UNIVERSITY OF FLORIDA
TRAINING REACTOR
LICENSE NO R-56
DOCKET NO. 50-83

SUBMITTAL OF RESPONSES TO NRC
REQUEST FOR ADDITIONAL INFORMATION
FOR THE CONVERSION FROM HIGH-ENRICHED
URANIUM TO LOW-ENRICHED URANIUM FUEL

**University of Florida Training Reactor, Facility License: R-56, Docket No. 50-83
Request for Change in Technical Specifications Approving HEU to LEU Conversion
With Responses to Requests for Additional Information**

Figure Q3-1 Relative Difference between the Peak-to-Average Power Width Profile

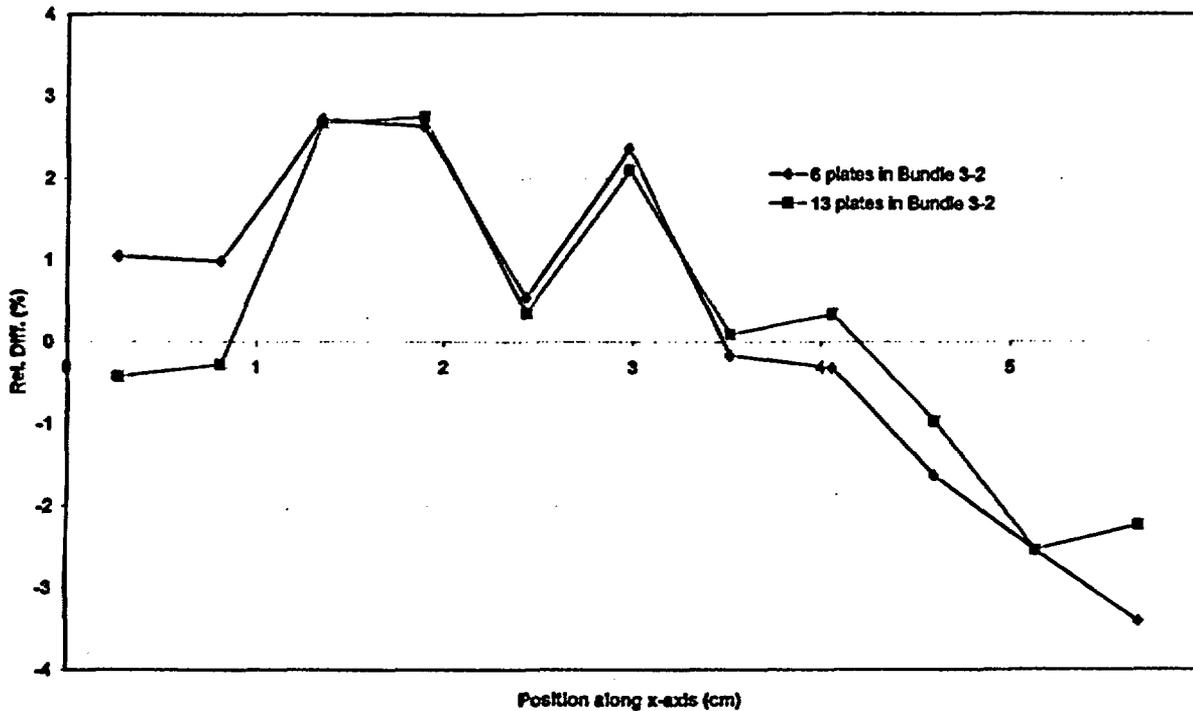
3. Section 4.5, Dynamic Design. Are any changes in fuel element location planned from the LEU reference core during the life of the core and if so, how does that affect the results of the safety analysis?

The changes in the peak-to-average ratio power width profiles for the critical plate was also studied as a function of the number of plates in the partial fuel bundle. Figure Q3-1 shows the relative difference in the peak-to-average ratio power width profiles between the nomina; case (10 plates) and the two cases.

The small changes in the power distribution presented in Table Q3-1, Table Q3-2 and Figure Q3-1 will have a minimal impact on the thermal-hydraulics analyses performed in the conversion submittal for the UFTR.

Figure 4-20 Calculated Values of True Reactor Power at Different True Coolant Flow Rates for ONBR = 1.0 at Three Inlet Temperatures

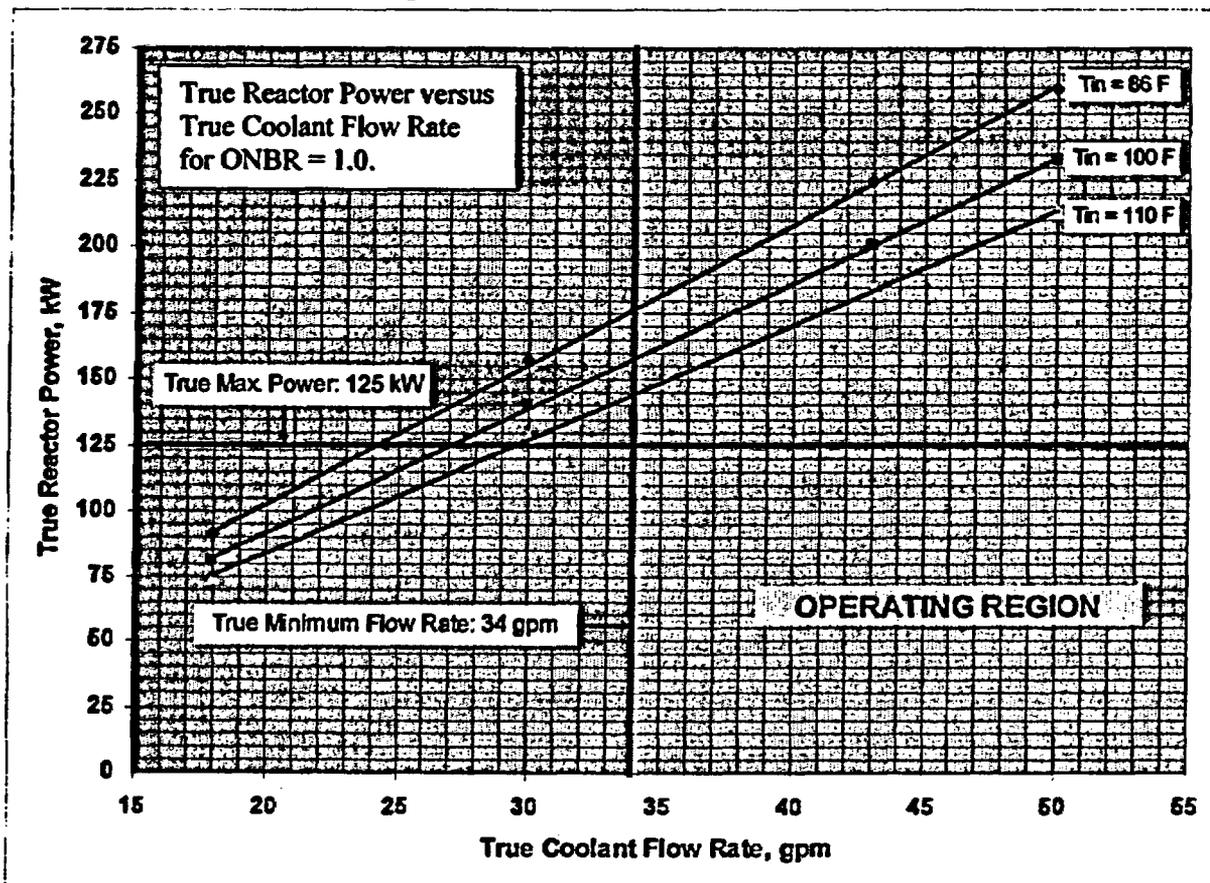
25. TS 2.1. Safety Limits. The regulations in 10 CFR 50.36 define safety limits (SLs) as limits upon important process variables that are found to be necessary to reasonably protect the integrity of certain of the physical barriers that guard against the uncontrolled release of radioactivity. Exceeding a SL means that there is a possibility that the physical barrier has failed. That is the basis for requiring Commission approval for reactor restart if a SL is exceeded. As pointed out in the SAR, fuel cladding is the physical barrier of concern. It is stated that the integrity of the barrier is protected if the cladding temperature is kept below the incipient melting temperature of 582°C for the 6061-aluminum cladding of the LEU silicide fuel (however, NRC has accepted an upper temperature for aluminum-clad fuel of 530°C based on blister formation temperature-see NUREG-1313, "Safety Evaluation Report related to the evaluation of Low-Enriched Uranium Silicide-Aluminum Dispersion Fuel for Use in Non-Power Reactors," Section 3.3.3). You have based your SLs on the prevention of localized boiling. This results in SL process variable values significantly below those needed to protect against clad blister.

As a result, in some cases, the accident analysis does not appear to support the technical basis for the SLs. For example, for the analysis of a step addition of reactivity of 0.6% dk/k into the core, the peak power for the LEU core with a SCRAM occurring is 320 kW. This would violate the SL in the proposed Technical Specification 2.1, namely, that "the power level shall not exceed 190 kW." Also, this result would indicate that the limiting safety system setting (LSSS) of 125 kW would not be in compliance with the regulations in 10 CFR 50.36(c)(1)(ii)(A) which states when a LSSS is specified for a variable on which a SL has been placed, the setting must be so chosen that automatic protective action will correct the abnormal situation before a SL is exceeded.

Please propose revised SLs and LSSSs, as needed, that support the conclusions in your accident analyses for reactivity insertions and loss-of-coolant or explain why the proposed values in your SAR are acceptable.

The value of 582°C will be changed to 530°C. This has no impact on the conclusions. The following figure provides information for selection of Limiting Safety System Settings (LSSS). Plotted in the figure are true reactor power versus true coolant flow rate for ONBR = 1.0 for three values of the coolant inlet temperature.

Based on the above figure, UFTR has decided on LSSS as follows: Power is 119 kW, coolant flow rate is 36 gpm, inlet temperature is 109 F, and outlet temperature is 155 F. These parameters were selected to account for uncertainties in measurements of the reactor power ($\pm 5\%$), coolant flow rate ($\pm 5\%$), and coolant inlet/outlet temperature ($\pm 1^\circ\text{F}$). Detailed analyses are provided in Appendix Q8.
